項次	規章名稱	修訂內容	新增項目	頁碼	說明
1	2.4安全輔助評等規章-2.4.1乘員狀態監測系統評等	◎		P.2-51	依 Euro NCAP 安全輔助評等規章 10.4 版，修訂乘員狀態監測系統(OSM)之駕駛狀態監測系統(DSM)及安全帶提醒裝置(SBR)評等標準。
2	3.10緊急煞車輔助系統(車對車)試驗規章	◎		P.52-170	依 Euro NCAP 緊急煞車輔助系統試驗規章 4.3.1 版，新增轉彎穿越路徑情境試驗、直行交匯路徑情境試驗、前方對向來車直行情境試驗、前方對向來車變換車道情境試驗。
3	2.4安全輔助(SA)評等規章-2.4.3緊急煞車輔助系統(車對車)評等	◎		P.171-205	依 Euro NCAP 安全輔助評等規章 10.4.1 版，新增轉彎穿越路徑情境試驗、直行交匯路徑情境試驗、前方對向來車直行情境試驗、前方對向來車變換車道情境試驗之評等標準。
4	3.12車道輔助系統試驗規章	◎		P.206-243	依 Euro NCAP 車道輔助系統試驗規章 4.3 版，修訂緊急車道維持輔助系統(ELK)、車道維持輔助系統(LKA)、車道偏離輔助警示系統(LDW)以及盲點偵測系統(BSM)試驗情境。
5	2.4安全輔助評等規章-2.2.4車道輔助系統評等	◎		P.244-257	依 Euro NCAP 安全輔助評等規章 10.4.1 版，修訂緊急車道維持輔助系統(ELK)、車道維持輔助系統(LKA)、車道偏離輔助警示系統(LDW)以及盲點偵測系統(BSM)評等標準。
6	3.14盲點輔助系統試驗規章	◎		P.258-264	修訂盲點輔助系統試驗條文內容。
7	2.4盲點輔助系統評等規章	◎		P.265-266	依 TNCAP 第 29 次工作組會議決議，修訂盲點輔助系統(BSS)評等標準。

2.4.1乘員狀態監測系統評等 <<本案暫以2.4規章編號說明乘員狀態監測系統評等條文修訂內容，後續擬修訂至2.1安全駕駛評等規章 >>

圖8：緊急車道維持輔助系統之道路邊緣試驗情境

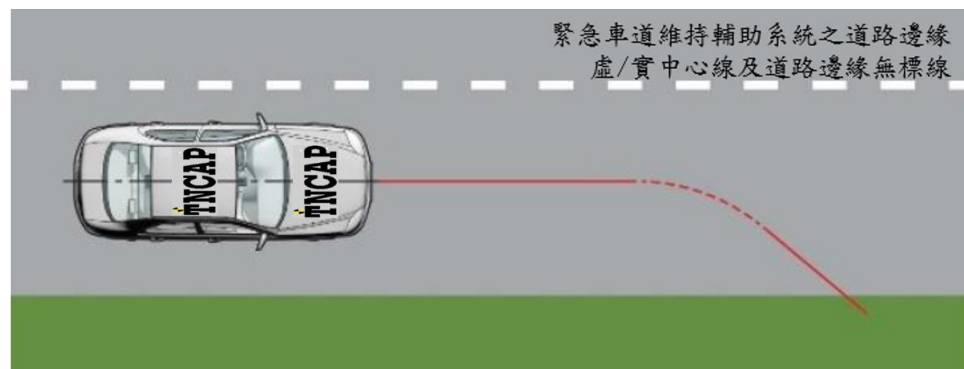
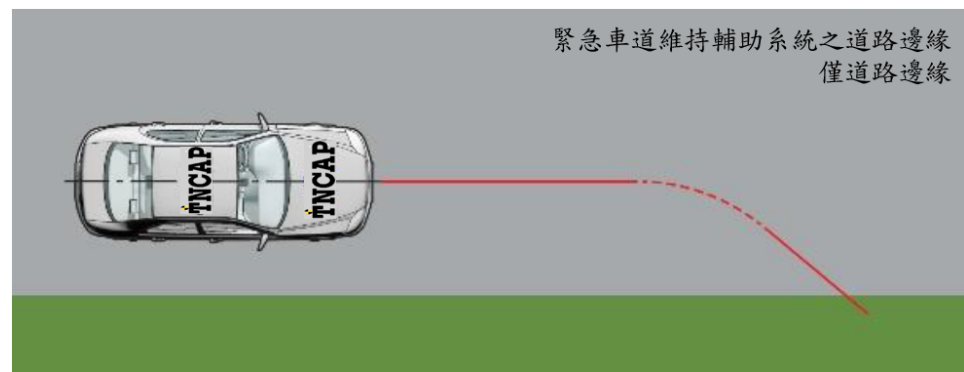
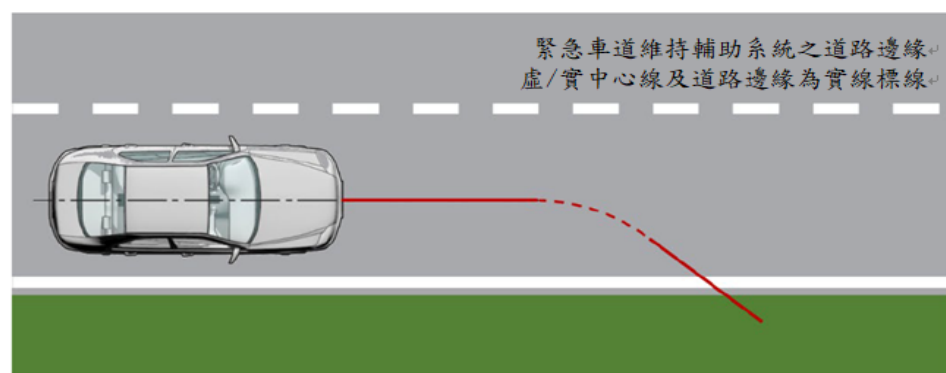
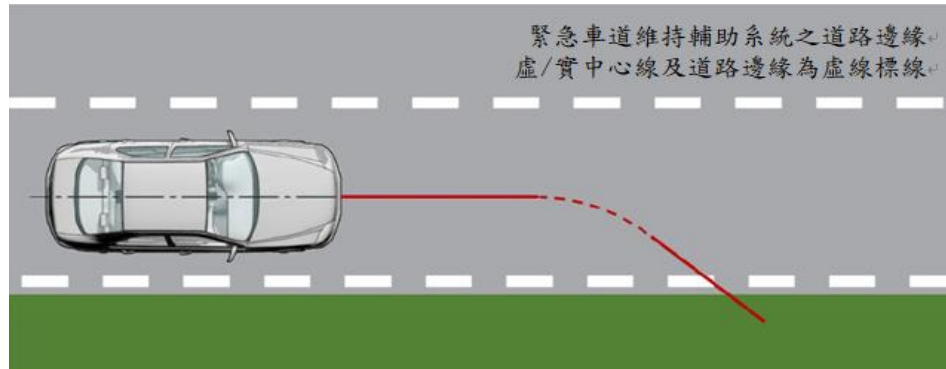
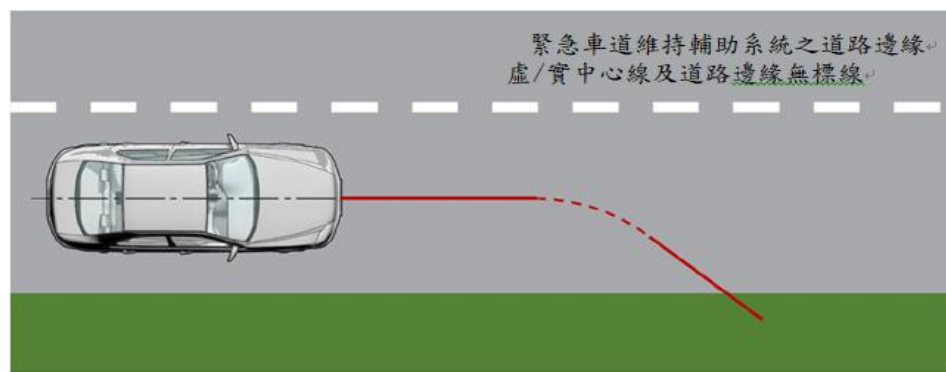
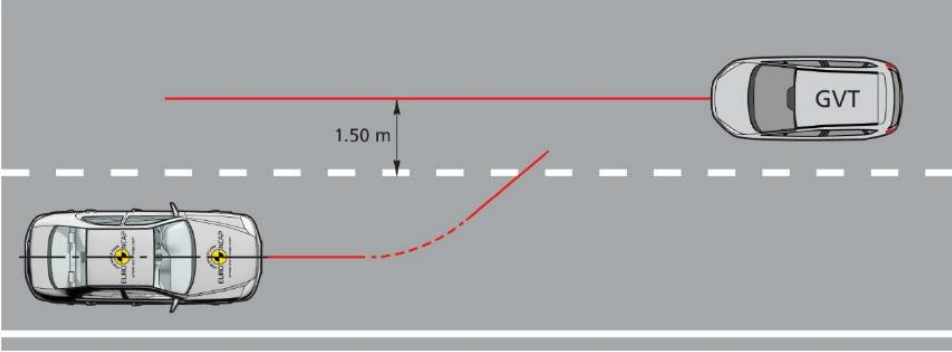
2025 年版 Euro NCAP 規章	2019 年版 Euro NCAP 規章	修訂 TNCAP 條文草案(第三版)	對應 TNCAP 第二版規章
 Figure 7-2: ELK Road Edge scenarios 7.2.4.2 <u>Solid line tests</u> ELK Solid line tests will be performed with 0.1 m/s incremental steps within the lateral velocity range of 0.2 to 0.6m/s for departures at both sides of the vehicle in a fully marked lane. (The non-tested side can be solid or dashed)  Figure 7-3: ELK Solid Line scenarios		(請參末頁圖示) 3.12.6.2.4.2 <u>實線試驗</u> <u>實線試驗應於側向速度 0.2 至 0.6m/s 範圍內，以每次增加 0.1 m/s 側向速度進行，分別朝車輛兩側之完整車道標線進行偏移。(未試驗另一側可為實線或虛線)</u>  圖 9: 緊急車道維持輔助系統之實線試驗情境	(請參末頁圖示)

圖8：目標車與試驗車之側向距離應距6.0公尺

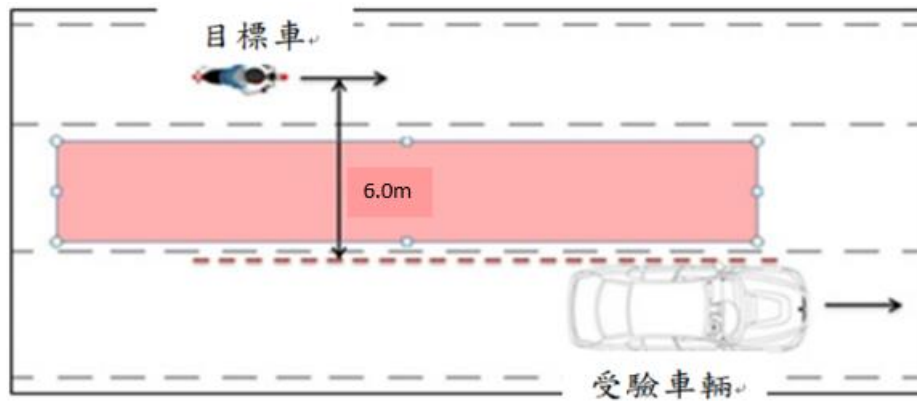
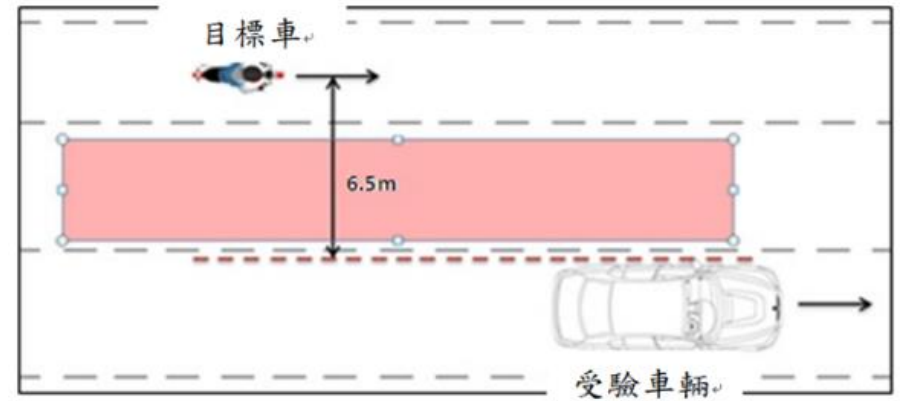
2025 年版 ASEAN NCAP 規章	2019 年版 ASEAN NCAP 規章	修訂 TNCAP 條文草案(第三版)	對應 TNCAP 第二版規章
6.3.5 Test Facility Layout Both vehicles need to slow down before making a U-turn when entering Zone C and returning to the starting line for the next run. The minimum repetition is four (4) runs for each side.  Figure 9: Test facility layout	6.3.5 Test Facility Layout Both vehicles need to slow down and make a U-turn when entering Zone C and return to the starting line for the next run. Minimum repetition is four (4) runs for each side.  Figure 3-6: Test facility layout	3.14.5.3.5 試驗場地配置 兩車進入 C 區皆應<u>於 U 型迴轉前減速</u>，返回起始線，準備下一回試驗。各側應最少重複 4 次試驗。 ...	3.14.5.3.5 試驗場地配置 兩車進入 C 區皆應<u>減速並 U 型迴轉</u>，返回起始線，準備下一回試驗。各側應最少重複 4 次試驗。 ...
5 TEST PROCEDURE 5.1 Conditioning 5.1.1 General A car (test vehicle) is used as delivered to the laboratory. There is no restriction on car selection. 5.1.2 Vehicle Preparation Set up the cameras inside and outside of the vehicle.	6 TEST PROCEDURE 6.1 Conditioning A car (test vehicle) is used as delivered to the laboratory. There is no restriction on car selection. 6.1.2 Vehicle Preparation Setup the on-board test equipment and instrumentation in the vehicle. Also fit any associated cables, cabling boxes and power sources.	3.14.7 盲點視覺系統試驗流程 3.14.7.1 試驗條件 ... 3.14.7.1.1 車輛整備 <u>在車輛內部與外部安裝攝影機。</u>	3.14.7 盲點視覺系統試驗流程 3.14.7.1 試驗條件 ... 3.14.7.1.1 車輛整備 <u>將車載測試設備及儀器安裝於車輛內，並裝配所有相關電線、接線盒及電源。</u>

圖8：目標車與試驗車之側向距離應距6.5公尺
